MEMO TO THE ARCHITECTURAL REVIEW COMMITTEE

May 19, 2021

Case Number: 2021-004293COA
Project Address: Spreckels Temple of Music / 55 Hagiwara Tea Garden Drive
Zoning: P (Public)

The Planning Department (Department) requests review and comment before the Architectural Review Committee (ARC) of the Historic Preservation Commission regarding a proposal to attach halo-lit letters to the frieze of the Spreckels Temple of Music located in the Music Concourse of Golden Gate Park (subject property, Assessor's Block No. 1700, Lot No. 001).

2 LIGHTBOX MOUNTING DETAIL R1
3" = 1'-0"

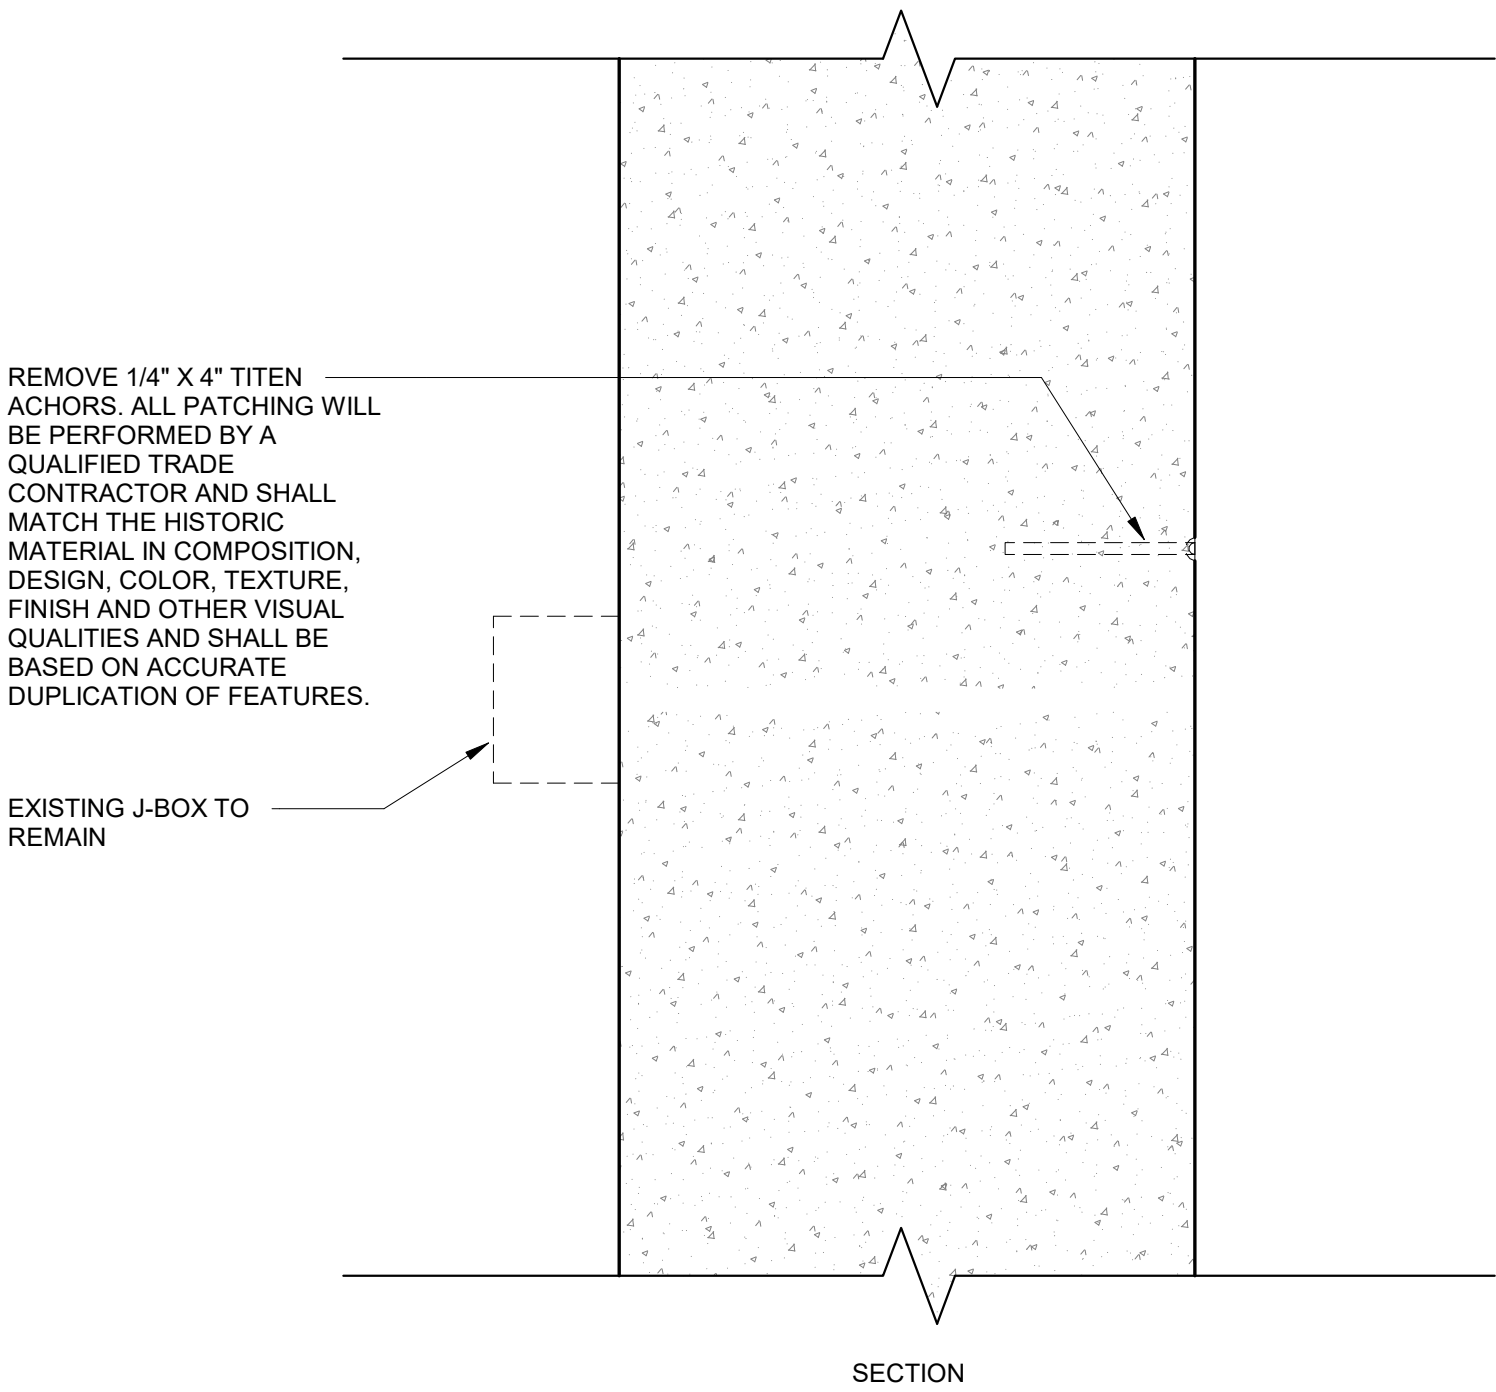
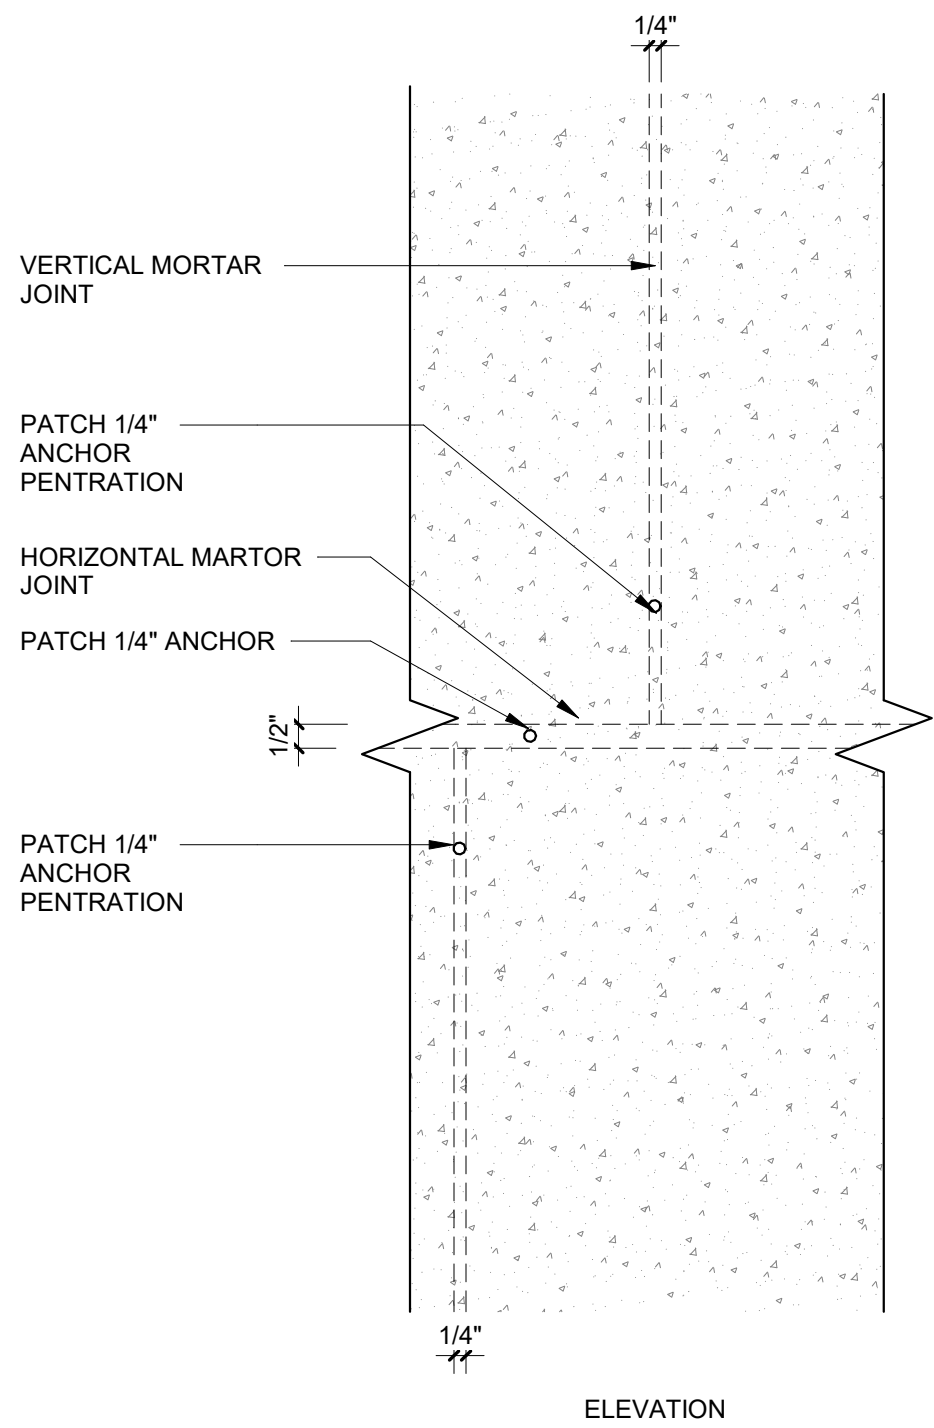
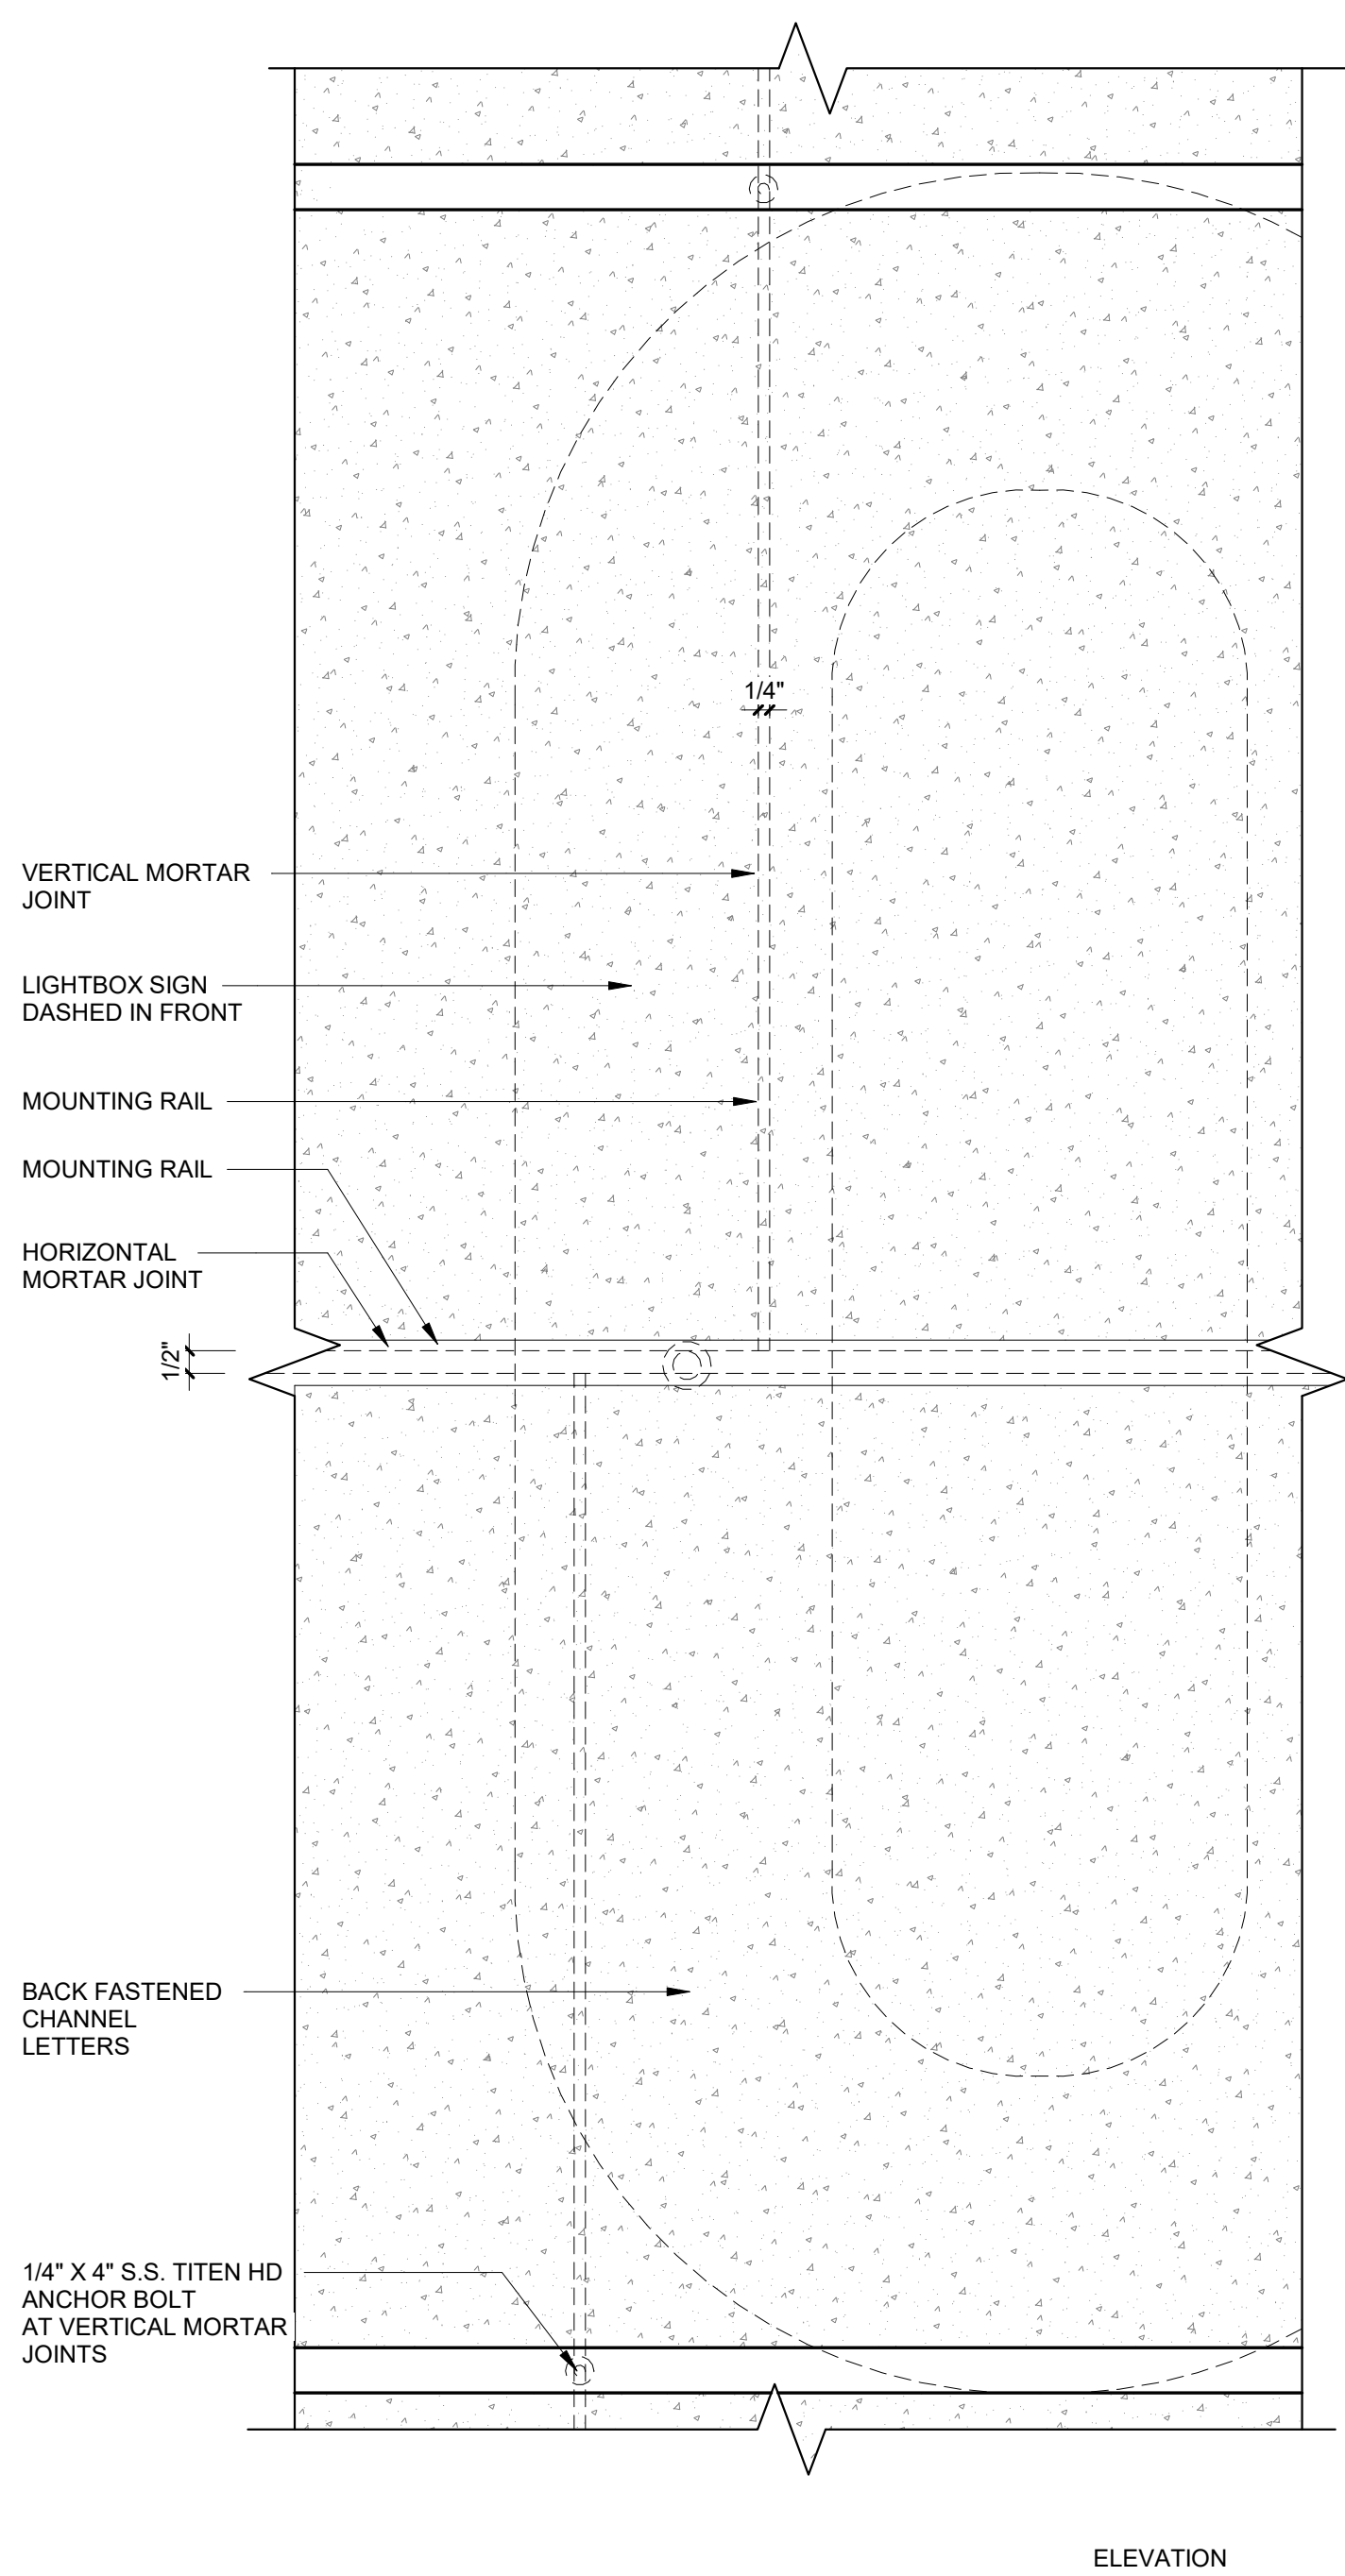
- 4) ***Detail.*** *The proposed project scope includes installation of a metal raceway and anchorage bolts secured into the mortar joints of the bandshell's frieze. The ¼" diameter anchorage bolts are appropriately sized to the width of the mortar joints so as to avoid damage to the Colusa sandstone exterior.*

- **Staff Analysis/Recommendation.** Staff find that the proposed anchoring in mortar joints to be consistent with our general guidance when securing signage on masonry buildings.

One drawing sheet of the set indicates the widths of the mortar joints in the area to which the lightbox lettering will be attached. Details of the anchorage are also included. These drawings illustrate that the anchors to be used for the lightbox lettering will be the same width or less than that of the width of the mortar joints. Thus, there will be no damage to the masonry during installation and when this temporary installation is deinstalled the anchors can be removed, and the affected area patched with a mortar matching the existing.
